AGENDA
HISTORIC PRESERVATION / DESIGN REVIEW COMMISSION
(SPECIAL MEETING)

Administrative Staff Report

Peter Spencer
Façade Grant and Design Review
920 Clark Street
April 10, 2013

Masonry

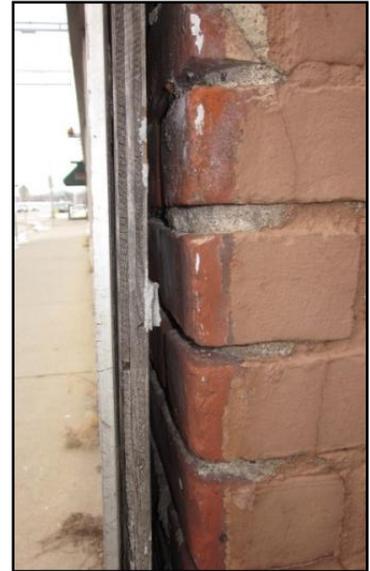
Analysis: The building has been painted several times, most recently in different shades of brown; therefore, the applicant is requesting to paint the building above the first floor commercial windows. Cleaning, prepping, and priming of the building are proposed prior to the application of paint. A two-tone color scheme with brown colors is proposed, accenting the cornice and detailing. Brick veneer is proposed to exist for the entire first floor, to be installed where the yellow brick currently exists below the windows. It is unknown as to what exists behind the solar panels, therefore restoration measures will be determined for that area upon removal of the panels.

Tuckpointing will occur to the original brick on the exposed columns once the yellow panels are removed. One bid for masonry related activities has been submitted by Don Dulak & Son Masonry, Inc. It is important to note that tuckpointing of the second floor façade has not been included within the masonry bid. Two bids for painting have been submitted, one by Bill Wanserski Painting & Wall Covering and the other by SDS Painting Co. Inc.

Findings: Unfortunately, the building may have several layers of paint, seen above in the photograph. Although painting is not preferred, it is recommended over stripping which can severely ruin the brick. Original brick, which exists underneath the column panels and possibly under the solar panels shall be rehabilitated. Yellow brick exists below the first floor windows which will not match the original red brick once exposed. In order to achieve a matching façade, the applicant has proposed to install brick veneer (face), replacing the existing yellow brick. Although brick veneer is not historic to the building it will enhance the aesthetics and more closely match the bricks found on the columns. As a definite color scheme for the second floor has yet to be finalized, staff would recommend that the applicant work with the HP/DRC chairperson and designated agent to make the final approval. Additionally, staff would recommend that the HP/DRC chair person and designated agent shall review/and or approve the renovation and rehabilitation activities behind the solar panels once they have been removed. As tuckpointing is a more specialized type of work and the contractor has a proven track record on other historic buildings within the City, staff feels that one masonry bid will suffice.
